Von: Tony Calenda [acalenda@agcert.com]
Gesendet: Dienstag, 25. Juli 2006 14:02
An: Castro, Javier; Kleiser, Thomas
Cc: David Higdon; Lenina Garnhart; Michael Mirda
Betreff: FW: MX49 CR4

Clarification Request No.4

Figure A2. Flare System.

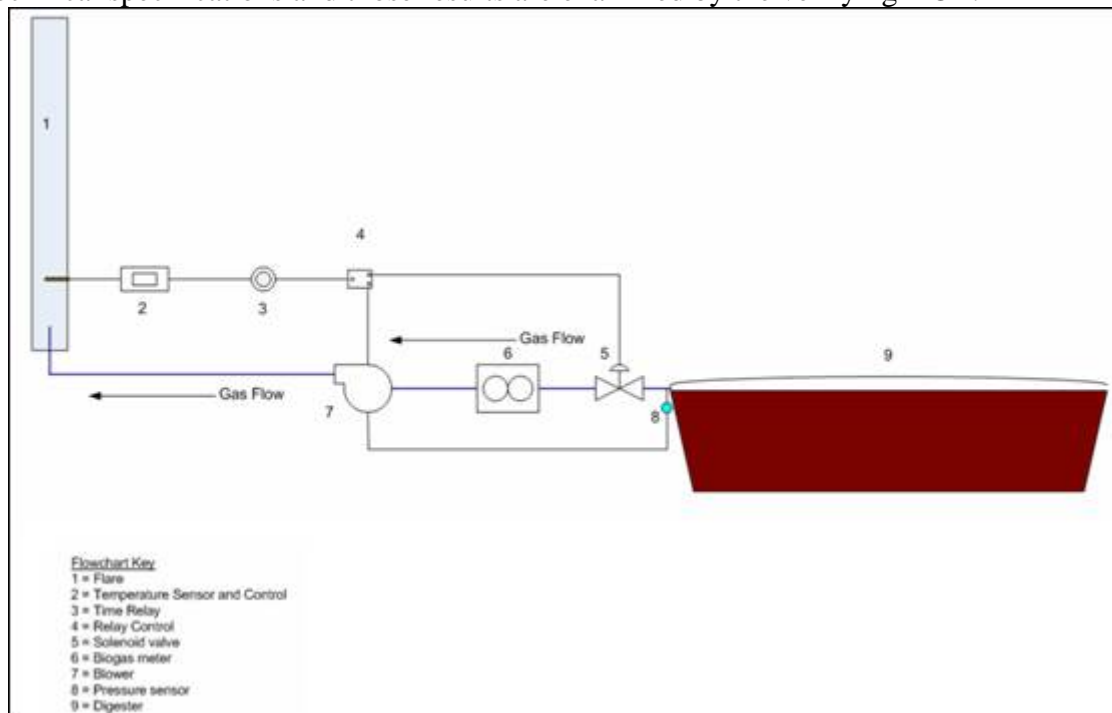
There is no information about the run time meter connected to a flame detector or a flame continuous temperature controller and about the accuracy of this equipment.

For the methane concentration in the gas before the flare, a positive pressure should be confirm in order to avoid the entrance of air, in this case the measurement base on CO2 is not valid. Additionally in the Table D1 says the methane content will be measured, in this case will be calculated base on the CO2 content.

There is no mention about the procedure for the measurement of the CH4 concentration after the flaring

The following paragraph is what we've included in the most recent PDDs (Section A.4.2) to address this concern. We plan on scaling down on the description in the PDD as we feel it provides information we don't want competitors knowing. We will be changing the CO2 content in table D1 to "measure and calculate". We don't see any requirement to measure CH4 concentration after the flaring process.

The flare system uses an automated process controls gas flow and ignition through combustion. As shown in Figure A2 when sufficient pressure is achieved within the digester, a pressure transducer/transmitter sends a signal to a relay control which in-turn opens a solenoid valve and activates the blower motor. The gas is sucked past a meter and routed to a solar panel operated constant ignition system. This causes the gas to ignite and the heat generated causes a thermocouple to send a signal to the relay allowing the solenoid valve to remain in the open state and the blower motor in operation. If at any point in the process the flame is extinguished due to insufficient gas, the thermocouple cools immediately and sends a signal to the system to stop biogas flow by shutting down the blower motor and closing the solenoid valve.

This process has the controls in place to ensure that any gas which has passed through the meter is combusted. The component parts are tested and verified functional on a periodic basis in accordance with technical specifications and those results are examined by the verifying DOE.
